**Central Queensland Coal Project
Chapter 1 Proponent Response to
IESC 2020-118 (EPBC 2016/7851)
Advice to Decision Maker**

Central Queensland Coal

09-Mar 2021

Figure 2-1: Distance between coal conveyor and Deep Creek

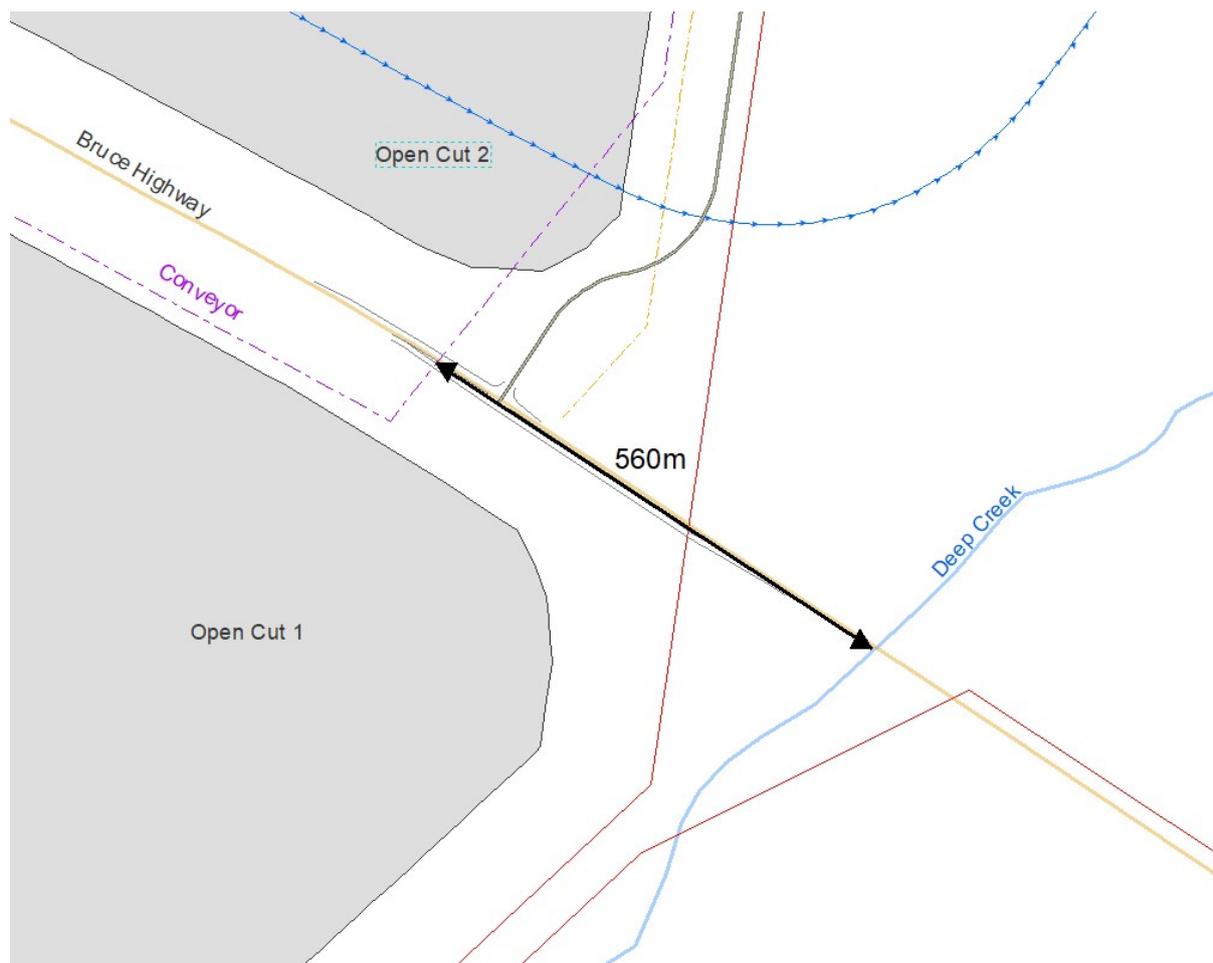
This statement is incorrect as it fails to recognise that the coal conveyor has been relocated specifically to avoid any impact or interaction with Deep Creek. The relocation of the conveyor is described in Section 16.4.8 of Chapter 16, and Section 3.6.4.3.10 of Chapter 3 (in response to the DAWE comments on SEIS v2). Specifically, the conveyor is now located at least 550 m west along the Bruce Highway from Deep Creek (at its closest extent) – See Figure 2-1 below. The relocation arose to address comments from DAWE in regards to potential flooding of the conveyor. Concerns about coal dust from the conveyor entering Deep Creek have not previously been raised by DAWE or DES.

The portion of the conveyor on the northern side of the Bruce Highway has been repositioned out of the extent of the 0.1% AEP flood event as can be seen in Figure 9-40 Chapter 9 – Surface Water. This flooding is the worst case scenario. The portion of conveyor in the shallow inundation of the floodplain will be raised above the level of the flooding and will be enclosed as shown in Figure 16-16 of Chapter 16 - Matters of National Environmental Significance.”

- If emissions of coal dust from conveyors to Deep Creek is a concern CQC suggests that this can be addressed via conditions requiring the conveyor to be designed, constructed and maintained to the standards required at the aforementioned coal terminals.

It is also worth noting that coal does naturally occur in the waterways around the Project area, due to the (naturally occurring) outcropping of the coal seam within Tooloombah Creek as evidenced by Appendix 6d – Surface Water/Groundwater Interactions Report particularly Figure 17 and section 4.4.2. A photo is included below as Figure 2-2 showing the outcrop during a period when the creek is dry. Given that the conveyor will be well away from interaction with Deep Creek and will not be running in flood events, it is considered that it poses a minimal threat to water quality as compared with the naturally occurring outcropping of the coal seam within Tooloombah Creek.
